E3614A-02-S

S E R V I C E N O T E

E3614A 60W Lab Bench DC Power Supply

POSSIBLE SHOCK HAZARD

3**REMOVE COVER**

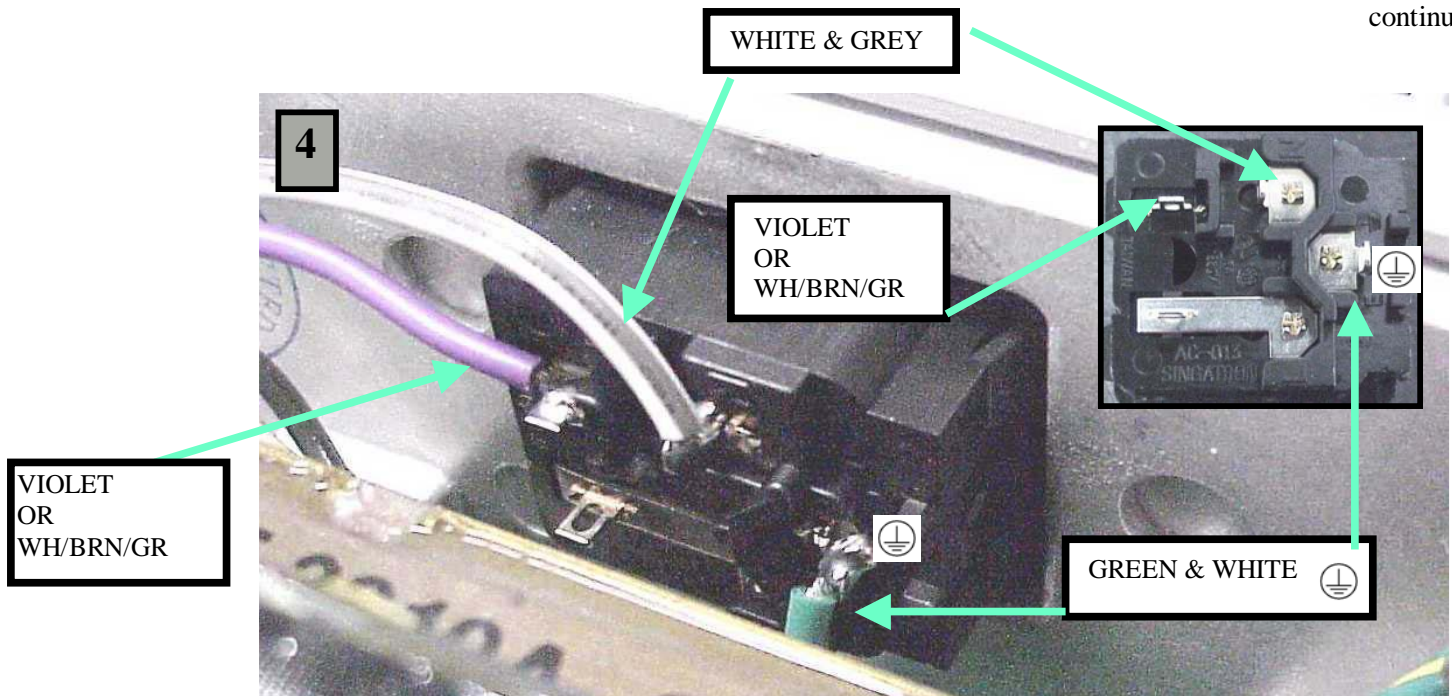
**CAUTION: TEST FOR LOOSE AC MODULE**

1. Make sure linecord is removed from outlet.
2. With linecord securely inserted in AC Module as shown, pull forcibly (2 times) in direction of arrow.

LOOSE AC MODULE

1. If the AC Module pulls out from Unit as shown it will need to be replaced.
2. If the AC Module remains in place it does not need to be changed. Put a mark on the AC input label in the lower left hand corner with indelible ink to indicate that the AC module has been checked. This label can be found below the AC module.

Pry Rear Bezel and Front Panel away from Cover in four places. Then lift Cover off unit.

Pry Tabs out on rear of Top Cover and lift Cover off of the unit

REPLACE MODULE with P/N 5065-6978. Before soldering perform “TEST FOR LOOSE AC MODULE” as shown in picture above. This will confirm that the new Module is secure. Solder wires and **REPLACE FUSE**.

100/120 VAC input-	use Fuse P/N 2110-0702 (2 amps, 250 volts)	E3610/11/12/14/15/16/17/20A
100/120 VAC input-	use Fuse P/N 2110-0918 (1.6 amps, 250 volts)	E3630A only
230 VAC input-	use Fuse P/N 2110-0599 (1 amp, 250 volts)	E3610/11/12/30A
230 VAC input-	use Fuse P/N 2110-1346 (1 amp, 250 volts)	E3614/15/16/17/20A

CAUTION: WIRING MUST BE CORRECT OR H_⊥ TSINK COULD BE AT LINE POTENTIAL.

CAUTION: MAKE SURE SAFETY GROUND IS ATTACHED TO HEATSINK
